**SOLICITATION AMENDMENT
MODIFICATION DE L'INVITATION**

Title - Sujet Security System Upgrade - Vancouver Security System Upgrade - Vancouver	
Solicitation No. - N° de l'invitation 86100-191076/A	Amendment No. - N° modif. 002
Client Reference No. - N° de référence du client 86100-191076	Date 2021-01-13
GETS Reference No. - N° de référence de SEAG PW-\$\$HN-329-79500	
File No. - N° de dossier hn329.86100-191076	CCC No./N° CCC - FMS No./N° VME
Solicitation Closes - L'invitation prend fin at - à 02:00 PM Eastern Standard Time EST on - le 2021-02-08 Heure Normale du l'Est HNE	
F.O.B. - F.A.B. Plant-Usine: <input type="checkbox"/> Destination: <input checked="" type="checkbox"/> Other-Autre: <input type="checkbox"/>	
Address Enquiries to: - Adresser toutes questions à: Dumaresq, Steve	Buyer Id - Id de l'acheteur hn329
Telephone No. - N° de téléphone (613) 296-1704 ()	FAX No. - N° de FAX () -
Destination - of Goods, Services, and Construction: Destination - des biens, services et construction:

This amendment 002 is raised for the following:

Figure 1 – Layout of the Corridor Video Display for the Private Side of the Hearing Room Corridors

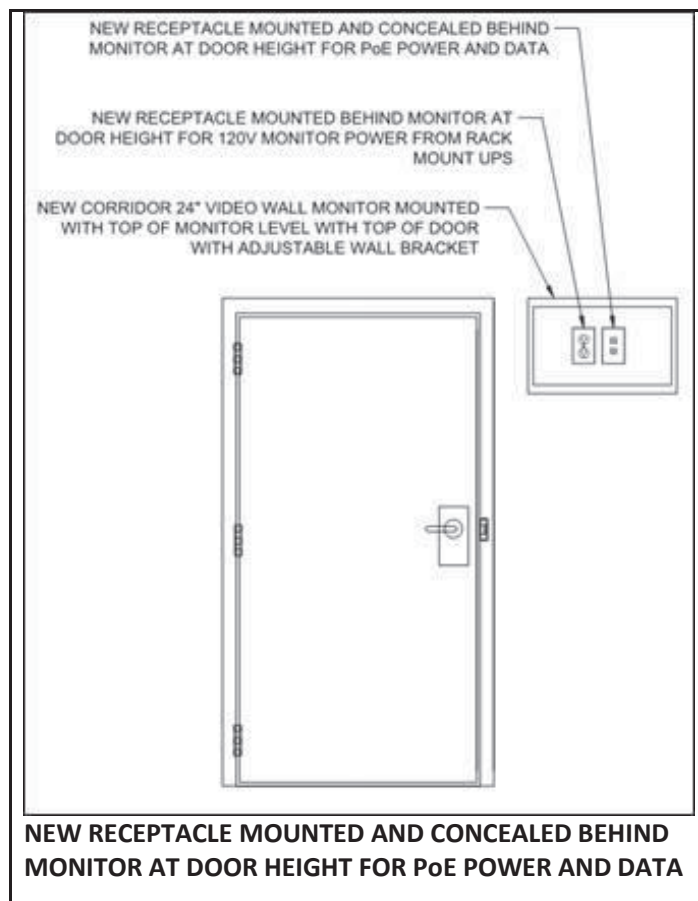
Question relating to the LCD Incident Monitors: It would seem that there was some conversation with Genetec on the interface to these LCD monitors. Is there a specific monitor that is to be used for this?

Hearing Room Private Side Corridor Displays:

Where applicable, each designated location shall be comprised of a 24" LED wall mount monitor and video decoder. A smaller monitor can be used where mounting space is limited or where there is a small number of simultaneous streams required.

The hearing room private side corridor displays shall be located adjacent to doors separating public spaces and private hearing room corridors. The video decoder shall be programmed to display camera feeds of cameras viewing the proximate public side of the door.

The video decoder shall meet the minimum technical specifications:

- Displaying up to 16 video sources in Multiview (the video sources shall be programmed to display adjacent public feeds of views through HDMI output)
- Video streams shall be HDTV 1080p at up to 30 fps using H.264
- VESA bracket shall be used to install the video decoder to the back of the LED wall monitor.

The following figure illustrates the typical Corridor Video Display for the Private Side of the Hearing Room Corridors:

**NEW RECEPTACLE MOUNTED BEHIND MONITOR AT
DOOR HEIGHT FOR 120V MONITOR POWER FROM RACK
MONT UPS**

**NEW CORRIDOR 24 PO VIDEO WALL MONITOR
MOUNTED WITH TOP OF MONITOR LEVEL WITH TOP OF
DOOR WITH ADJUSTABLE WALL BRACKET**
